Economic and Social Council

Standardization of technical and safety requirements in inland navigation: Recommendations on Harmonized Europe-Wide Technical Requirements for Inland Navigation Vessels (resolution No. 61, revision 2)

Amendment proposal to the annex to resolution No. 61, revision 2, based on the European Standard laying down technical requirements for inland navigation vessels, edition 2021

Note by the secretariat*,**

Figure 1

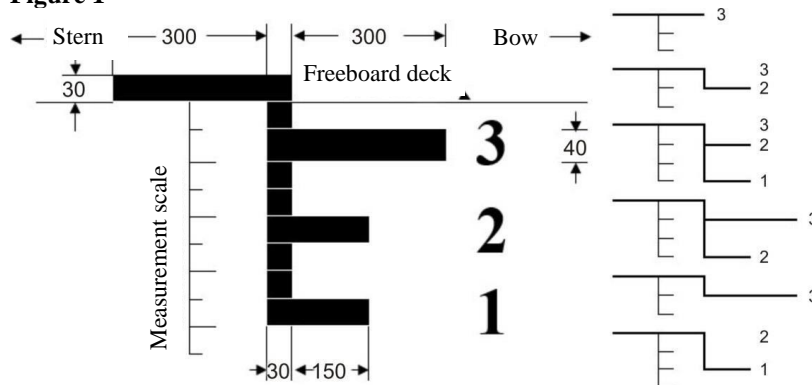
4-3.34 Draught marks are to be designed as follows:

(a) **The topmost draught mark points towards the stern and is a rectangle 300 mm long and 30 mm high** ~~The draught marks for zone 3 shall consist of a rectangle 300 mm long and 40 mm deep, the baseline of which is horizontal and coincides with the plane of the maximum authorized draught. Any differing draught marks shall include such a rectangle. If the topmost draught mark is the one applicable to zone 3, it is 40 mm high.~~

(b) **The additional draught marks to be added point towards the bow and the following provisions apply:**

(i) Draught marks for zone 3 ~~shall consist of~~ **comprise** a rectangle 300 mm long and 40 mm high;

(ii) Draught marks for zones 1 and 2 **comprise** a rectangle 150 mm long and 30 mm high, the baseline of which is horizontal and coincides with the plane of the maximal authorized draught.

(c) **If the draught mark to be added for zone 3 or 4 coincides with the uppermost draught mark, the latter can be dispensed with.**

4-3.4 The number of the zone, in characters 60 mm high × 40 mm deep, is to be added next to the draught marks towards the bow;¹ in the case of zone 4, the number can be dispensed with.

4-3.5 The draught marks according to paragraphs 4-3.3 and 4-3.4 and their orientation are to be in accordance with figure 1.

Figure 2

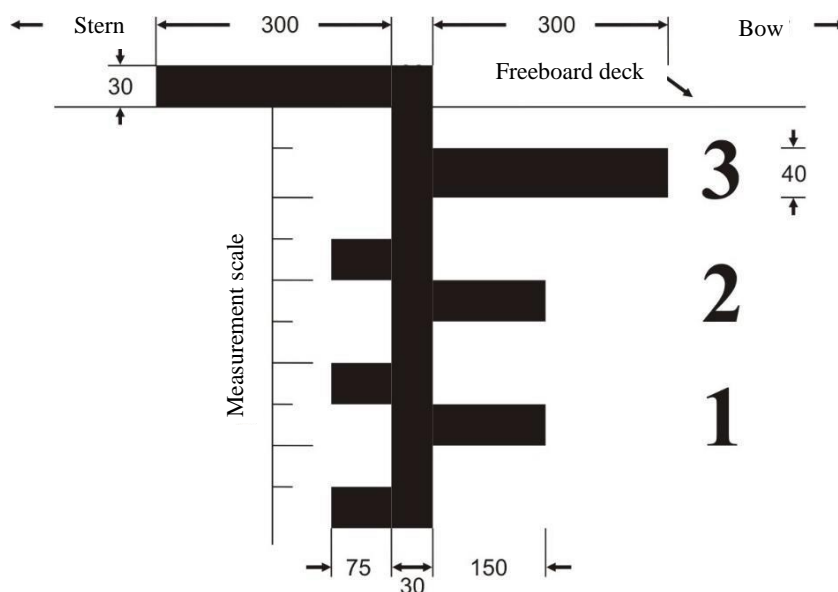
4-3.11 In the case of vessels with open holds, in addition to the provisions of paragraph 4-3.6 the draught marks for the relevant zones are to be supplemented by a rectangle 75 mm long by 30 mm high, pointing aft, the base of which is horizontal and coinciding with the level of the maximum permissible draught for navigation in the zone in question with open holds.

4-3.12 The draught marks according to paragraph 4-3.11 and their orientation are to be in accordance with figure 2.

Figure 4-3.8 3
Freeboard mark

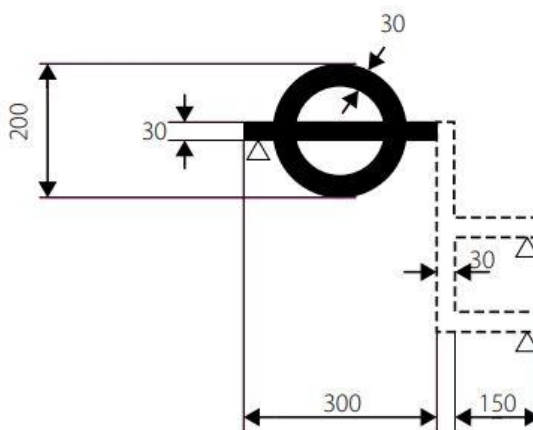
4-3A.4 4-3.8 The centrally located measurement/draught scale for zones 1 and 2 may be replaced by a freeboard mark.

The freeboard mark consists of a ring intersected through its centre by a horizontal line which shall be supplemented if necessary by additional freeboard lines.

The width of the ring and of all the other lines of the freeboard mark shall be 30 mm; the outer diameter of the ring shall be 200 mm; the length of the horizontal line intersecting the ring shall be 300 mm; and the size of the numerals designating the zones shall be 60 x 40 mm (figure 4-3.8 3).

The centre of the ring shall be placed amidships. The lower edge of the horizontal line which intersects the ring shall pass through the centre of the ring and shall constitute the freeboard line.

If the vessel is intended to navigate in several navigation zones, a vertical line and additional freeboard lines 150 mm in length shall be applied forward of the centre of the ring.
